No. EL/3.2.61/3

**MODIFICATION SHEET NO. RDSO/2018/EL/MS/0471, Rev '0'**

Modification in the bottom plate of M/s Schneider make Single bottle VCBs.

Modification Sheet No-RDSO/2018/EL/MS/0471 Rev '0'

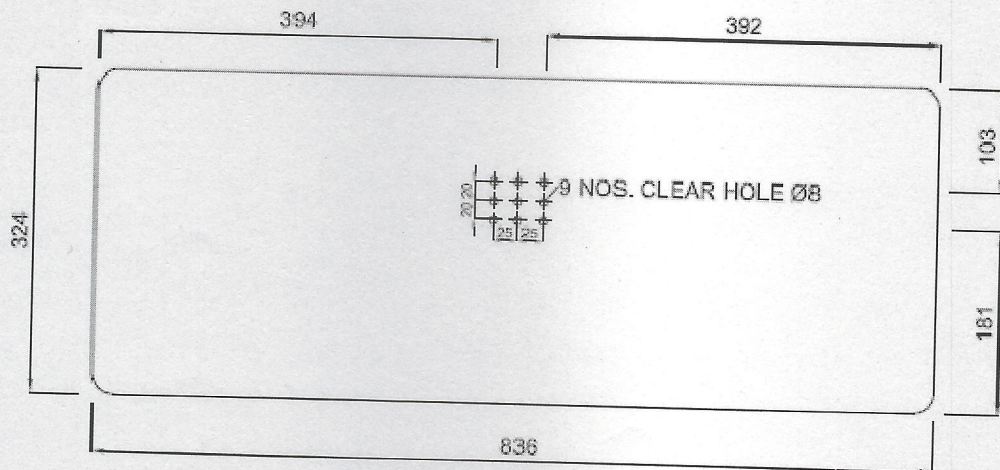
Nine hole of 8 mm diameter are to be drilled in the bottom plate of VCB as shown in drawing No. RDSO/2018/EL/MS/0471, Rev '0' in annexure A
